Planning Observation

Warehouse Development

Reg. Ref. SD22A/0382

Lands South Side of Lucan Road, Ballydowd &
abutting Hermitage Gardens, Ballydowd, Lucan,
Co. Dublin

Figure 4.0 Extract of proposed site plan showing a significantly proportioned warehousing unit within close proximity to a number of dwellings.

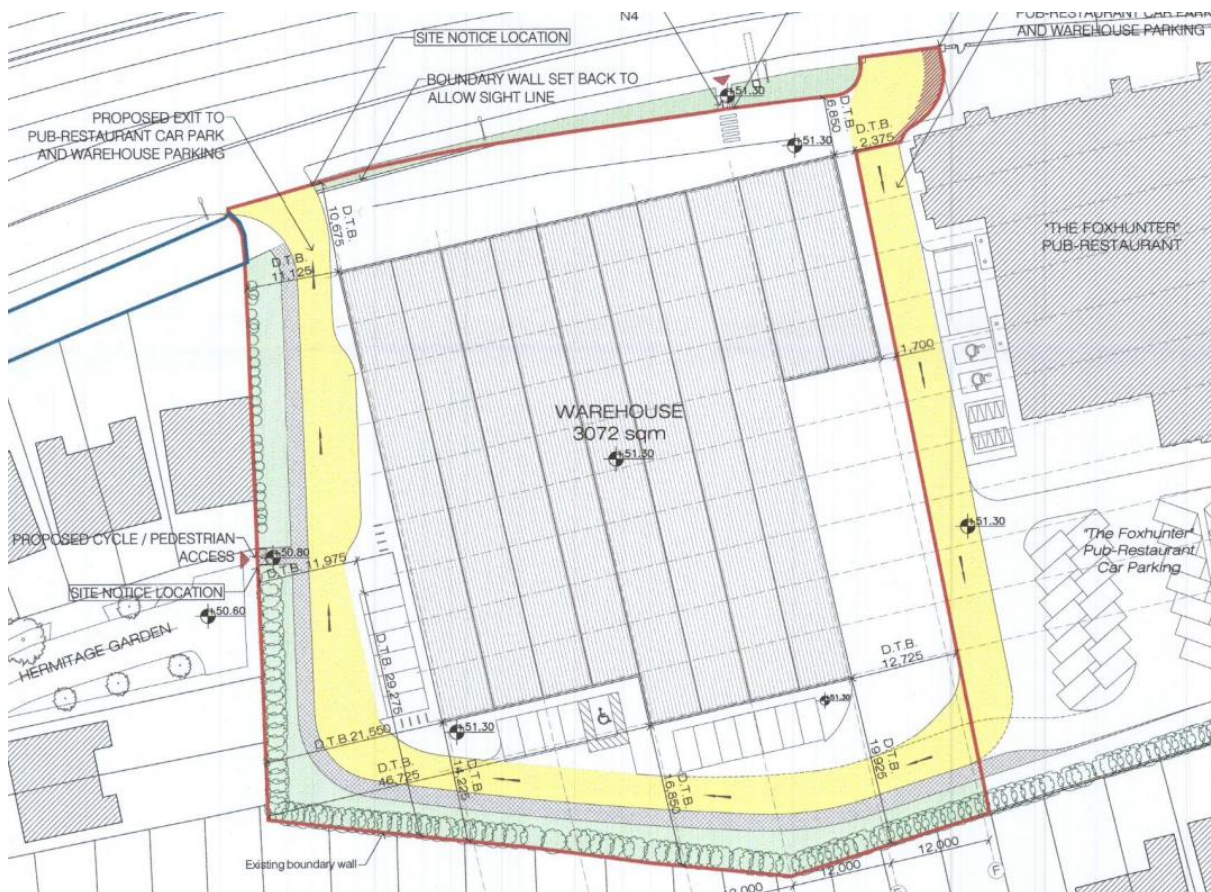
The proposal in its current scale is considered excessive and unsuitable for the application site. A reduced warehouse would be suited for the site.

Figure 11.0 Extract of site plan showing the location of the proposed pedestrian access.

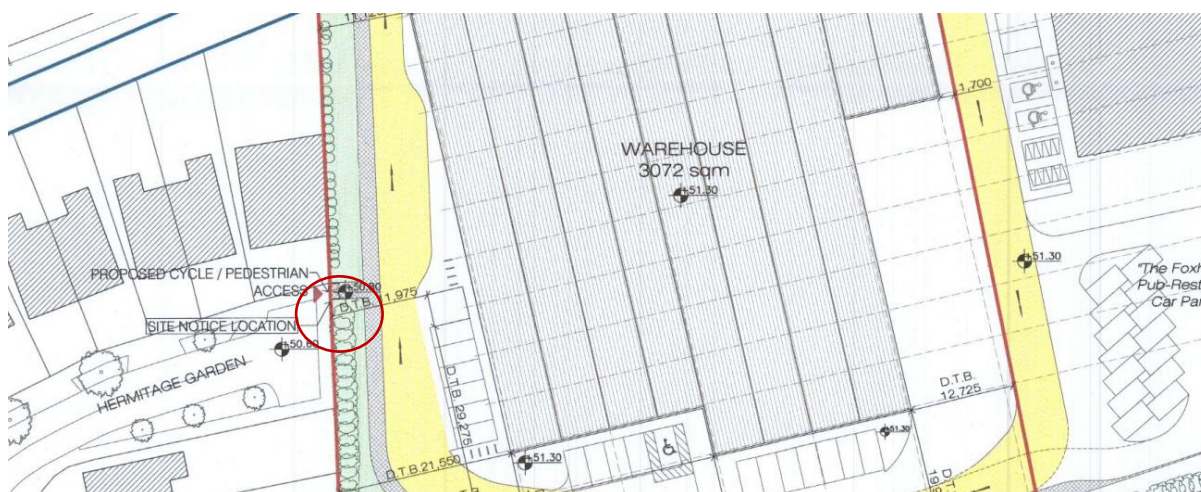
It is considered that the proposal will reduce the level of safety and security of the immediate area, specifically by the provision of a new pedestrian gate from the site to Hermitage Garden along the site’s western boundary. This gate has not been subject to discussions or agreement between the Applicant and our clients and it is a concern that this will result in safety and security concerns which have not been considered. The proposal seeks to provide a gate to allow permeability from the private cul-de-sac housing estates which adjoin the site, through the warehousing premises, and to the Foxhunter pub. This passageway would not be adequately surveilled and it would be a concern that this would give rise to anti-social behaviour in the evenings and nights. No details on lighting have been provided so the safety and usability of the route have not been satisfactorily demonstrated. The Foxhunter pub is currently open as last as 12.30am so patrons of the pub could potentially leave the premises at this time and cause noise disturbance to the existing, quiet housing estates via the new gate. The provision of this gate may create precedence. It is also a concern that should this be provided, the Applicant will later seek to amend this from a pedestrian access into a vehicular access, as was proposed under the previous planning application.

It is also considered that there would be a security concern as no details have been furnished with the planning application to demonstrate whether CCTV or policing would occur at the site. A lack of information has resulted in the proposed access being insecure and unsafe.

Figure 13.0 Extract of proposed site plan with a preferred option (blue shading) for access and entry which would impact on surrounding dwellings to a lesser degree.

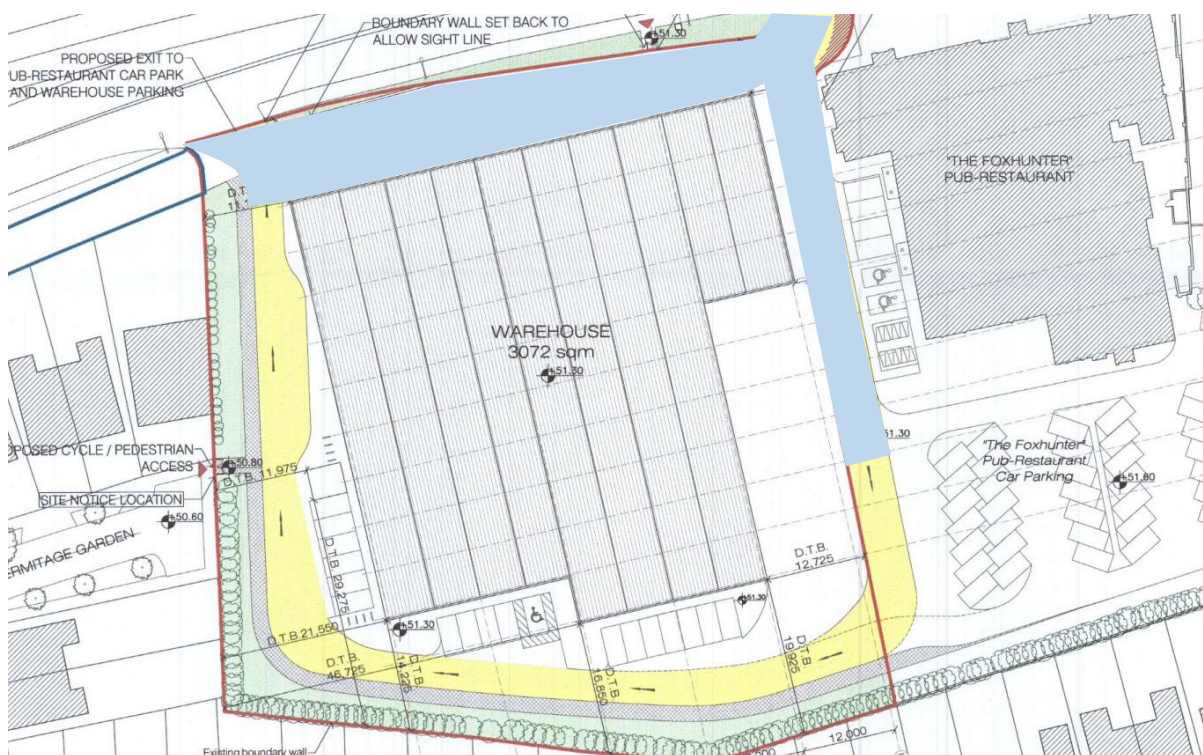
One immediate concern is the fact that the proposal amends the existing access from the Foxhunter pub to prevent its use as an exit. As a result, all traffic leaving the Foxhunter pub and the application site will traverse through the application site, along the southern and western boundaries to exit at the new access point. The east – west road will be located to the rear of private gardens of existing dwellings along Hermitage Gardens. The regular use of this would reduce amenity of these spaces by way of noise and air pollution and there is also potential to light overspill depending on tree and hedgerow conditions. A preferred option would have been for the Applicant to consider an option where all traffic would stay to the north of the application site.

The below method of exiting would have protected residential amenity. To facilitate such a proposal, the scheme would also be reduced in massing and scale so it fits with the site to a more appropriate degree. The scheme would also be redesigned so as to have loaded bays at northern elevation, potentially via ‘flipping’ the scheme. The residential amenity of our clients has not been considered by the applicant.
